**PLANNING APPROVAL,
PLANNED UNIT DEVELOPMENT &
SUBDIVISION STAFF REPORT**

Date: May 20, 2004

<u>NAME</u>	Pleasant View Baptist Church
<u>DEVELOPMENT NAME</u>	Pleasant View Baptist Church Subdivision
<u>LOCATION</u>	1517 Katye Street (West side of Katye Street, 120'± South of Bank Avenue, extending to the East side of Ruby Street, 190'± South of Bank Avenue)
<u>PRESENT ZONING</u>	R-1, Single-Family Residential
<u>AREA OF PROPERTY</u>	1.6± Acres
<u>CONTEMPLATED USE</u>	Expansion of an existing church for paved parking and storage
<u>TIME SCHEDULE FOR DEVELOPMENT</u>	Immediately
<u>ENGINEERING COMMENTS</u>	Must comply with all stormwater and flood control ordinances. Any work performed in the right of way will require a right of way permit.
<u>TRAFFIC ENGINEERING COMMENTS</u>	Driveway number, size, location, and design to be approved by Traffic Engineering and conform to AASHTO standards. Sign and mark all one- way traffic flows according to MUTCD standards.
<u>URBAN FORESTRY COMMENTS</u>	Property to be developed in compliance with state and local laws that pertain to tree preservation and protection on both city and private properties (State Act 61-929 and City Code Chapters 57 an

SITE PLAN

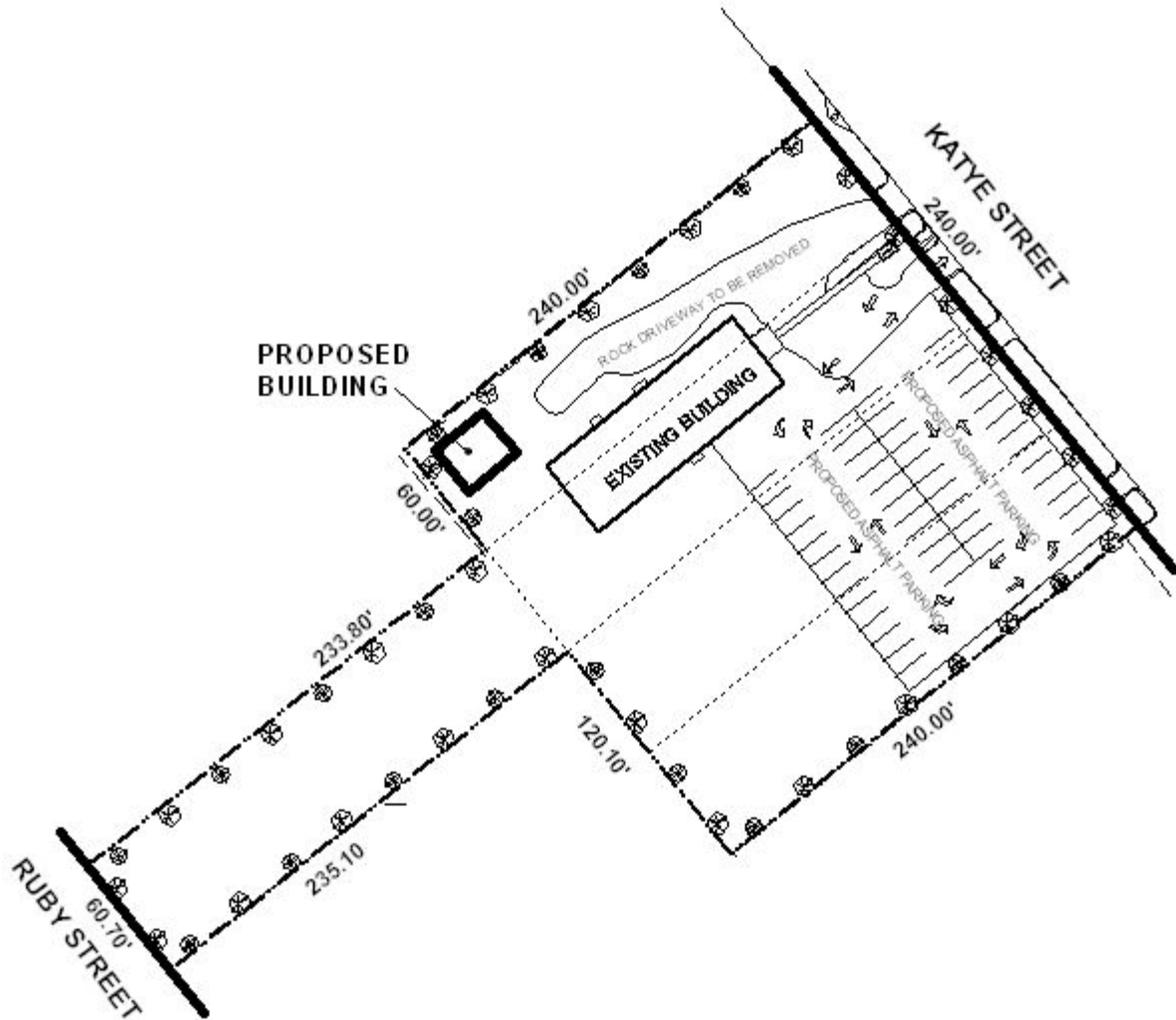
The surrounding area is predominately residential and includes a community center and another church. With the provision of a buffer, in compliance with Section IV.D.1. the new paved parking should actually serve as improvement to the area as gravel parking tends to shift and spill onto the adjoining properties and streets. The addition of the new parking area and storage building would necessitate full compliance with the landscaping and tree planting requirements of the Ordinance. Furthermore, as the parking area would be across the street from residential development, screening of the parking with a three-foot high fence or wall should be required. Additionally, all unused curb cuts should be closed, curbed, back-filled and sodded.

The PUD is required for the secondary building, which will be used for storage and possibly to park the church van. It should be noted that if a vehicle is parked in the structure, a paved drive leading to the structure would be required. Additionally, as outlined in the Traffic Engineering Comments, all traffic flows should be signed and marked.

The Subdivision application would simply consolidate multiple lots into one lot. The site plan indicates that there is 23.1 feet of right-of-way from the centerline of Katye Street to the site; a standard width right-of-way provides 25-feet from the centerline to private property. Therefore, the dedication of the necessary right-of-way to provide 25-feet from the centerline of Katye Street should be required. Additionally, as required by the Subdivision Regulations, a sidewalk should be provided along all street frontages.

RECOMMENDATION **Planning Approval** Based upon the preceding, this application is recommended for approval subject to the following conditions: 1) provision of a buffer, in compliance with Section IV.D.1. where the site adjoins residential development; 2) full compliance with the landscaping and tree planting requirements of the Ordinance; 3) provision of a three-foot high fence or wall along Katye Street to screen the parking area from the residential development on the North side of Katye Street; 4) closure of all unused curb cuts, including curbing, back-fill and sod; 5) if the new building is used to park the church van that a paved driveway be provided; 6) the marking and signing of all traffic flows as required by Traffic Engineering; 7) provision of sidewalks along all street frontages; and 8) full compliance with all municipal codes and ordinances.

Planned Unit Development Based upon the preceding, this application is recommended for approval subject to the following conditions: 1) provision of a buffer, in compliance with Section IV.D.1. where the site adjoins residential development; 2) full compliance with the landscaping and tree planting requirements of the Ordinance; 3) provision of a three-foot high fence or wall along Katye Street to screen the parking area from the residential development on the North side of Katye Street; 4) closure of all unused curb cuts, including curbing, back-fill and sod; 5) if the new building is used to park the church van that a paved driveway be provided; 6) the marking and signing of all traffic flows as required by Traffic Engineering; 7) provision of sidewalks along all street frontages; and 8) full compliance with all municipal codes and ordinances.

Subdivision The plat meets the minimum requirements of the Subdivision Regulations and is recommended for Tentative Approval subject to the following condition: 1) the dedication of the necessary right-of-way to provide 25-feet from the centerline of Katye Street.
